APPLICATION NO.	FILING DATE	FIRST NAMED INVENTOR	ATTORNEY DOCKET NO.	CONFIRMATION NO.
10/619,398	07/15/2003	Johannes Hendrikus van Lith	VAND10	7671

Application Number: 10/619,398
Filing Date: July 15, 2003
Appellant(s): VAN LITH ET AL.

EXAMINER'S ANSWER

Enlarged copy of JP 63-280,946

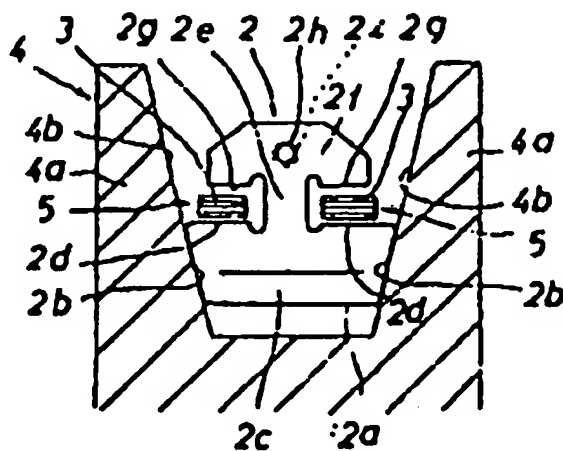
In fig. 1 of Natsushiro et al. clearly shows that the transitional region has two different curvatures. One of ordinary skill in the art would distinguish the two different radii. Irrespective of the scale of the drawing, it can be clearly seen that a transition region between 2d and 2b exist. As can be see, there is a small radius as illustrated, joining a larger radius 2d and the pulley contact surface 2b.

Applicant contended that Natsushiro et al. the fails to disclose the transition surface having two different radii and that due to the scale of the figures, the two different radii cannot be discerned. In response, it should be noted that fig. 1 of Natsushiro et al. clearly shows that the transitional region has two different curvatures. One of ordinary skill in the art would distinguish the two different radii. Irrespective of the scale of the drawing, it can be clearly seen that a transition region between 2d and 2b exist. There is a small radius as illustrated, joining a larger radius (see fig. 4. The

larger radius joins the supporting surface (2d) while the smaller radius joins the pulley-contacting surface (2b).

Regarding arguments relating to the size of the drawing, it should be noted that it does not matter that the feature shown is unintended or unexplained in the specification. The drawings must be evaluated for what they reasonably disclose and suggest to one of ordinary skill in the art. In re Aslanian, 590 F.2d 911, 200 USPQ 500 (CCPA 1979). See MPEP § 2121.04. Therefore, one of ordinary skill in the art would be able to interpret the drawing to identify the connection joint between the first or large radius and the pulley contacting surface is a small radius. Such small radius or round edge is well known in the art to reduce the sharp edges. See attached enlarged drawing figure illustrating the transition comprising a large radius and a smaller radius. The enlargement clearly shows the connection between the radius R1 (see fig. 4) and the

contact surface 2b is a curved surface. Therefore, for reasons given above the rejection is deemed proper.
